SITE INSTRUCTION

PROJECT: HAMPTON MANOR
25 BAKER HILL BLVD
STOUFFVILLE, ONTARIO

SITE INSTRUCTION: E-3

Purpose: To coordinate with architectural, interior designer, mechanical changes and client requested revisions.

DRAWN CM	CHECKED MG	SCALE 1:200
DATE SEPT. 2015	PROJECT 14-016	DRAWING E-1
		OF 12

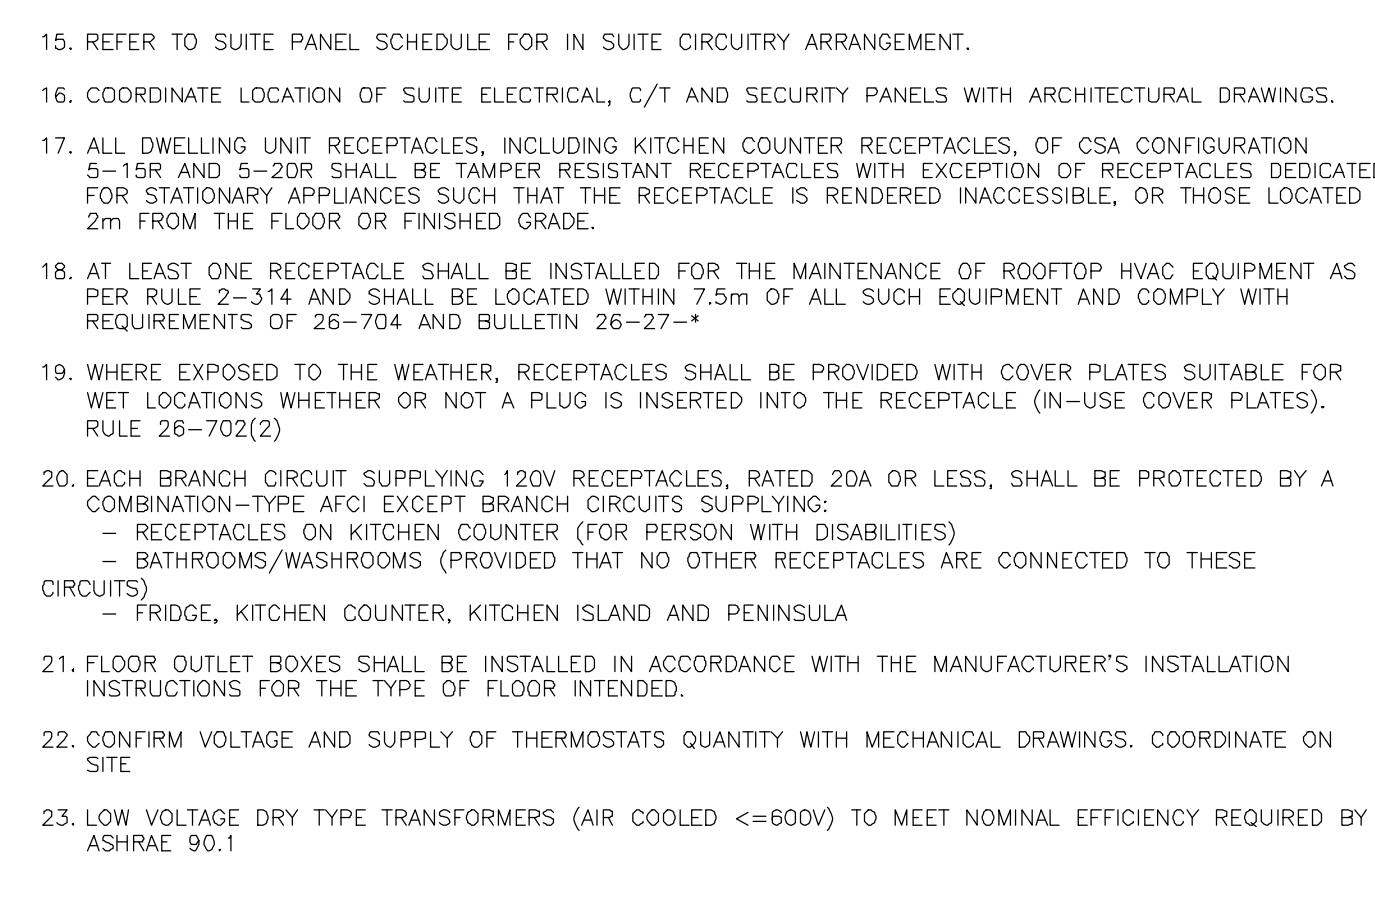
1.0 Reference Drawing E-1 (Site Plan) Issued

1.1 Relocate: Main incoming communication lines to site conditions

TITLE MECHANICAL PENTHOUSE ELECTRICAL		
PROJECT PROPOSED RESIDENTIAL DEVELOPMENT 25 BAKER HILL BLVD.		
OWNER ROYAL PINE HOMES STOUFFVILLE, ONTARIO		
DRAWN CM	CHECKED MG	SCALE 1:100
DATE SEPT. 2015	PROJECT 14-016	DRAWING E-8
		OF 12

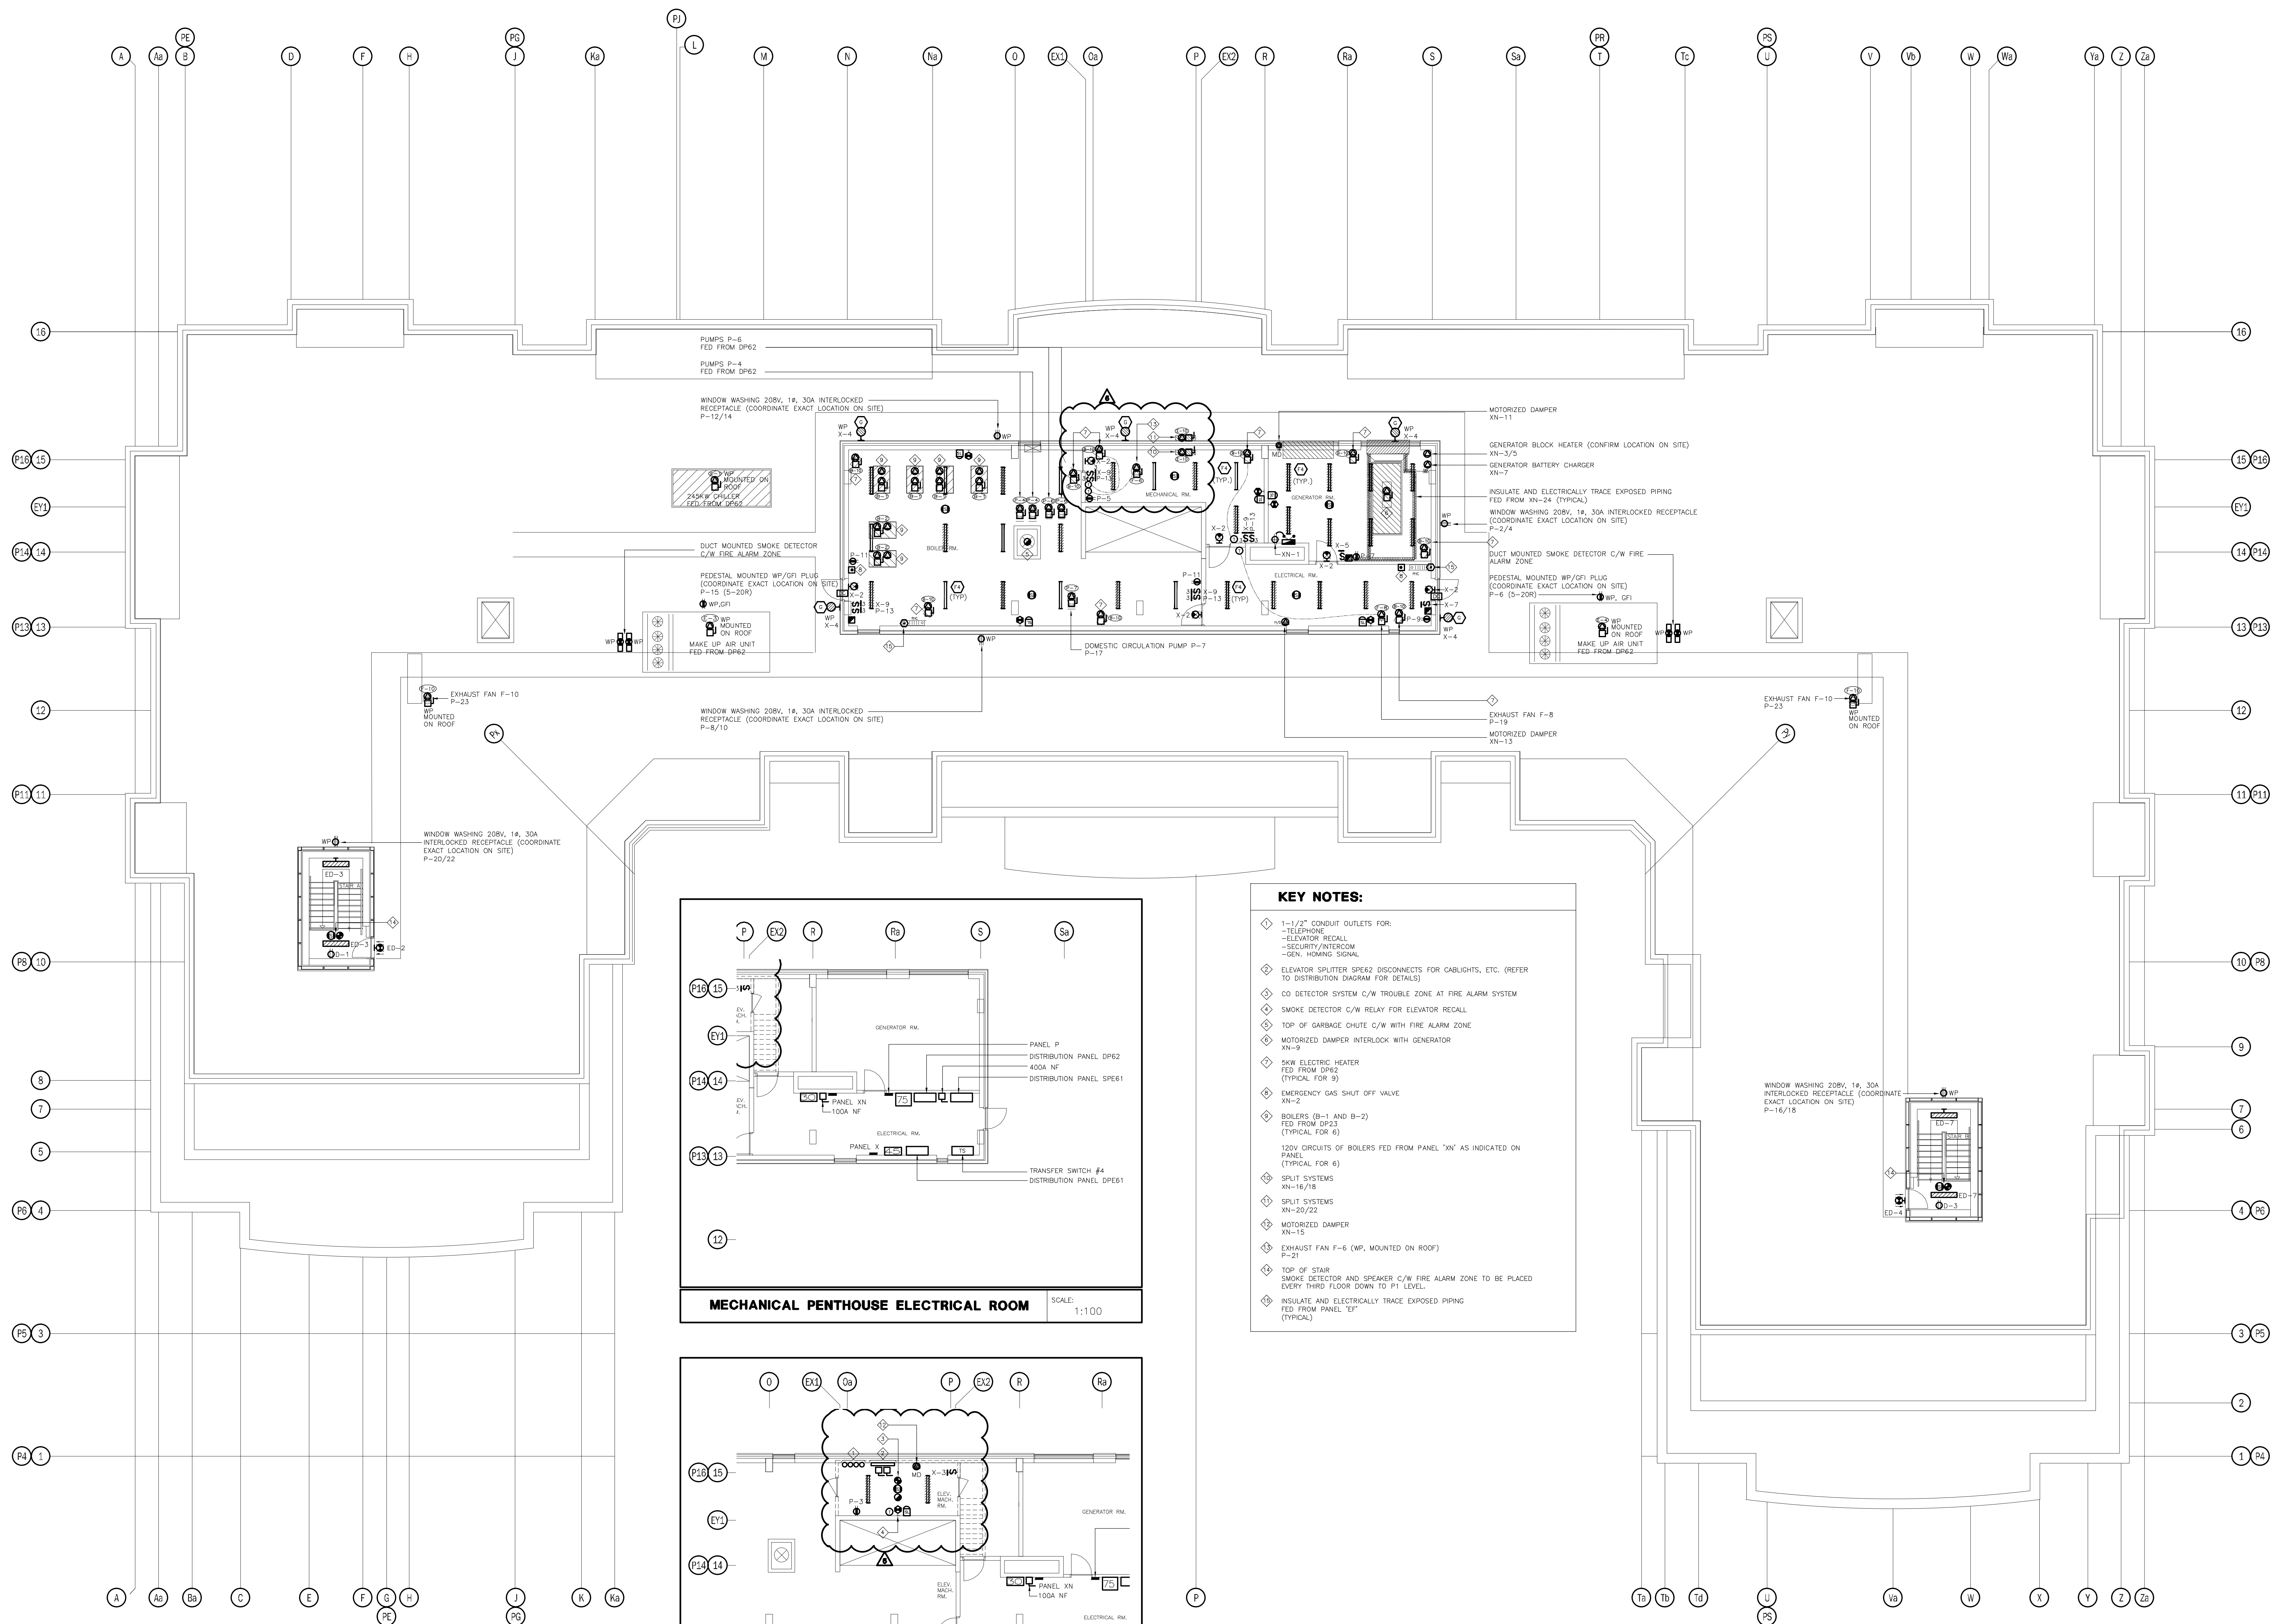
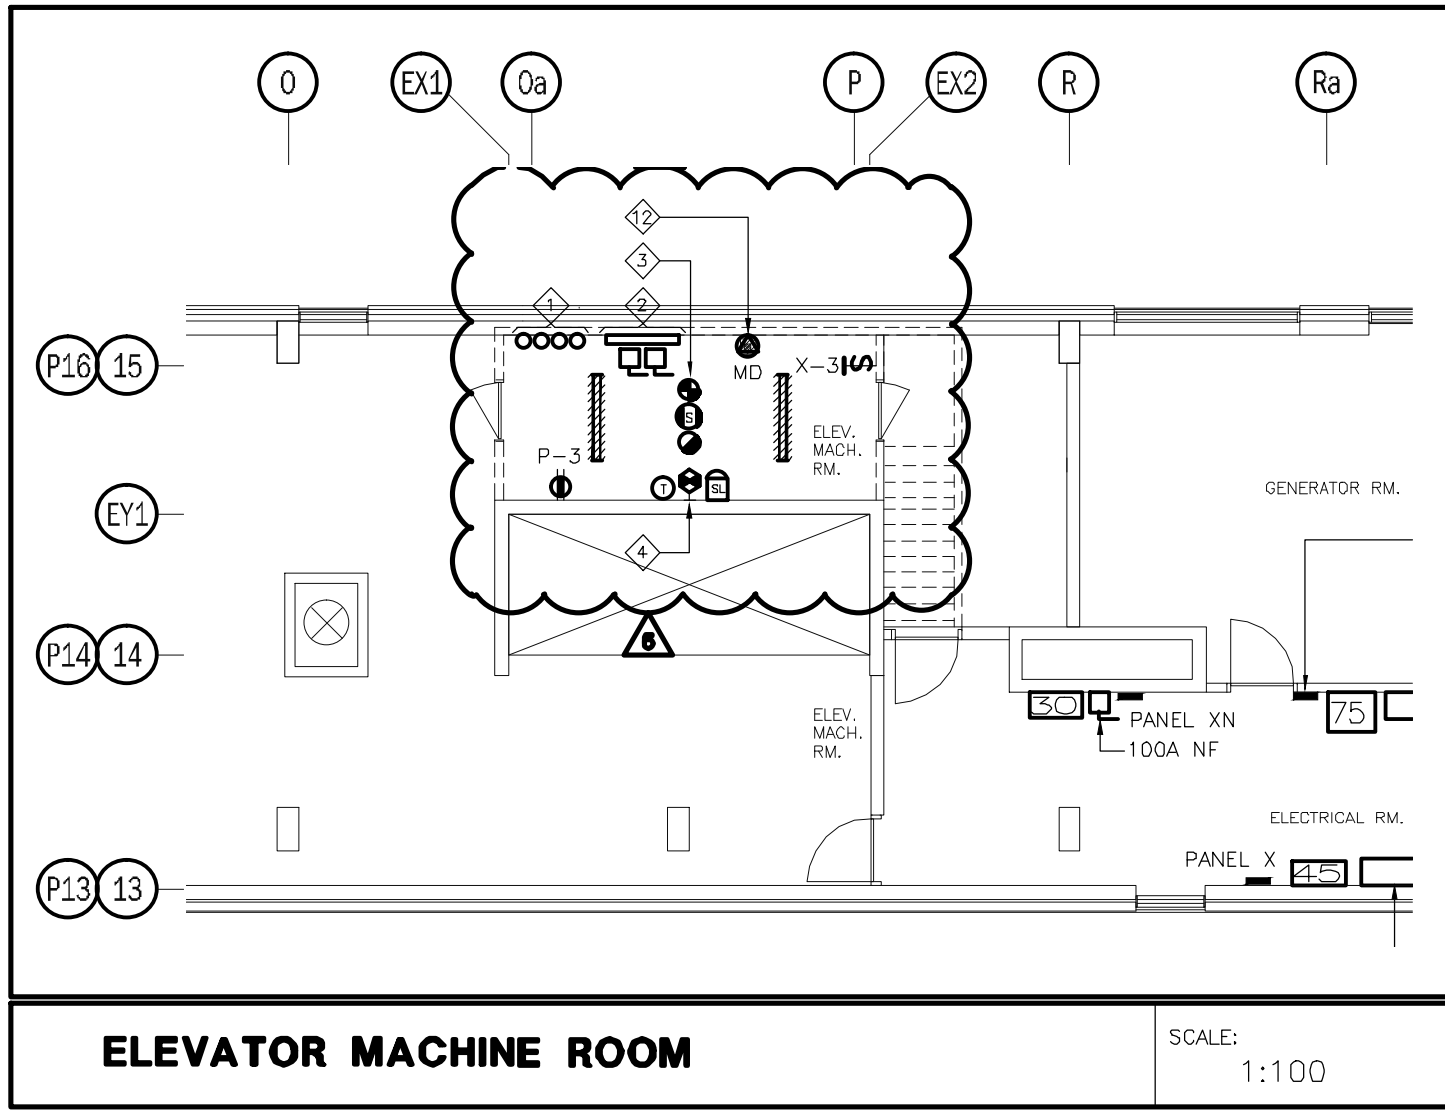
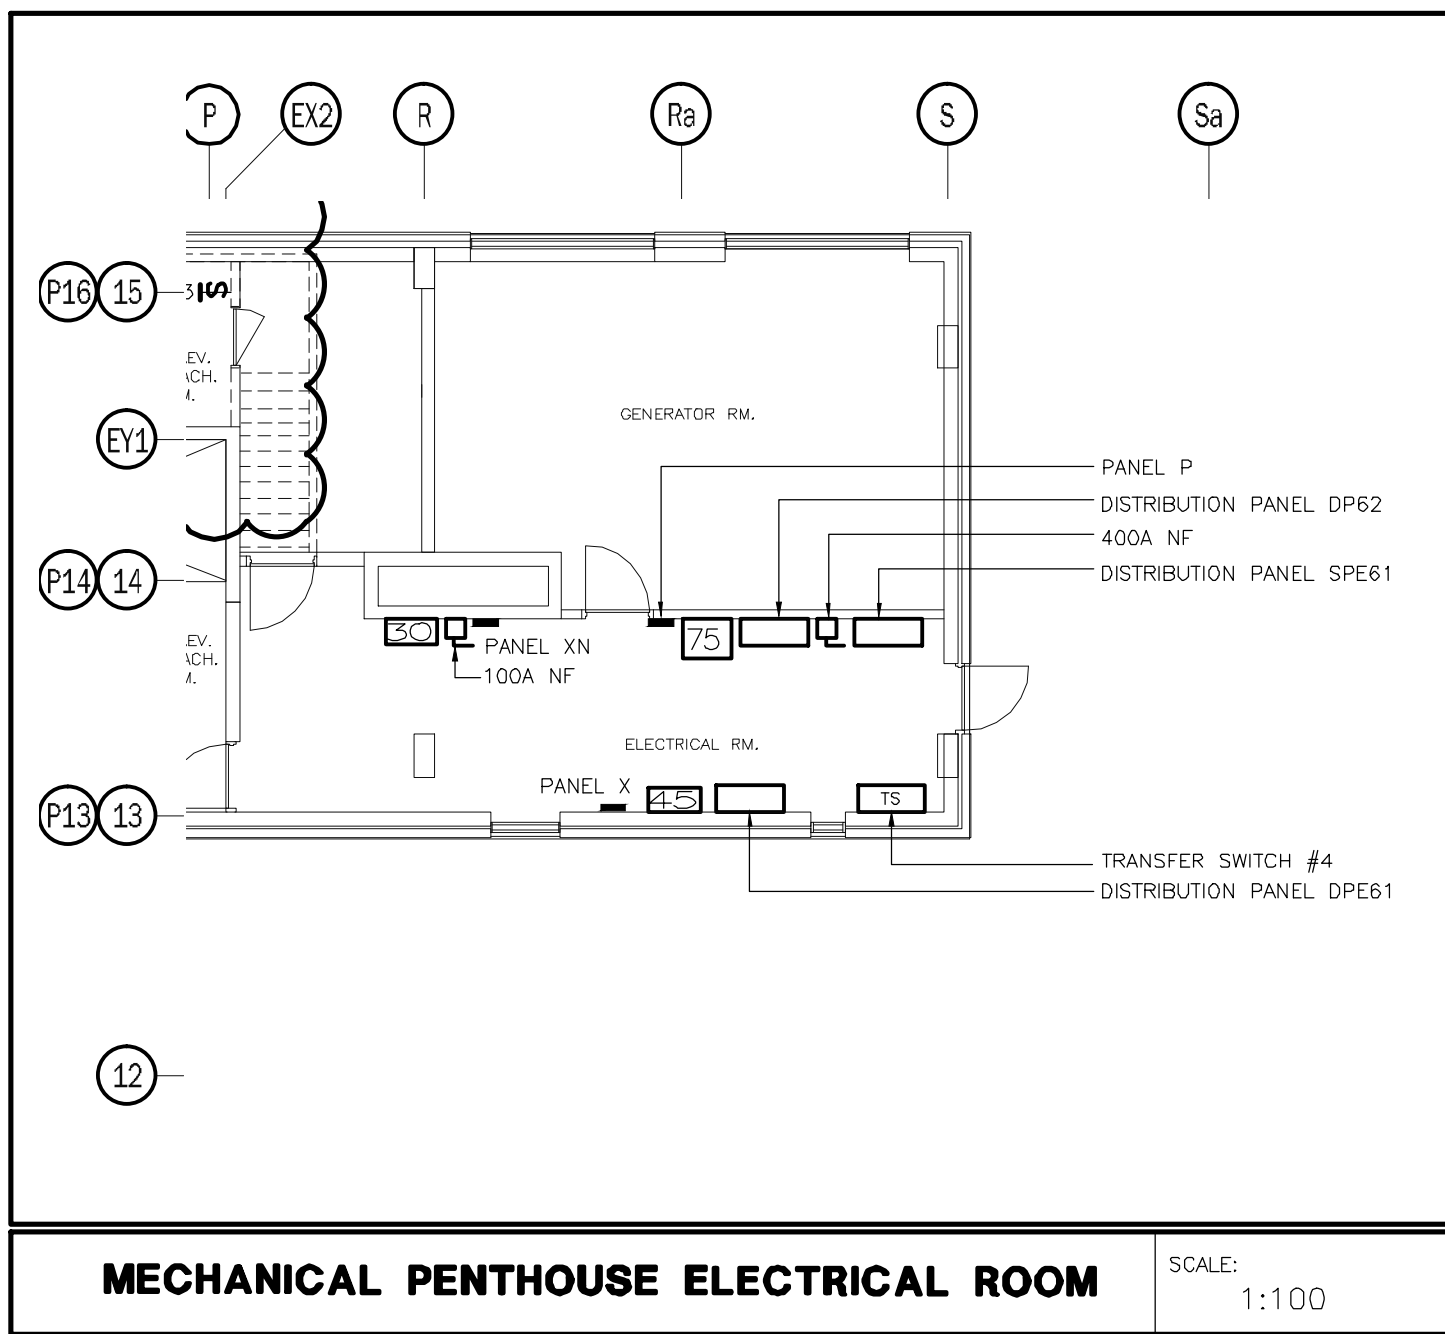
4.0 Reference Drawing E-8 (MPH) Issued

- 4.1 Relocate: Elevator machine splitter SPE62, conduit location, CO, smoke detectors, lighting fixtures, power outlet, power connections for exhaust fan E-6 and split systems, blower and coil and condensing unit to suit revised location of the elevator machine room.
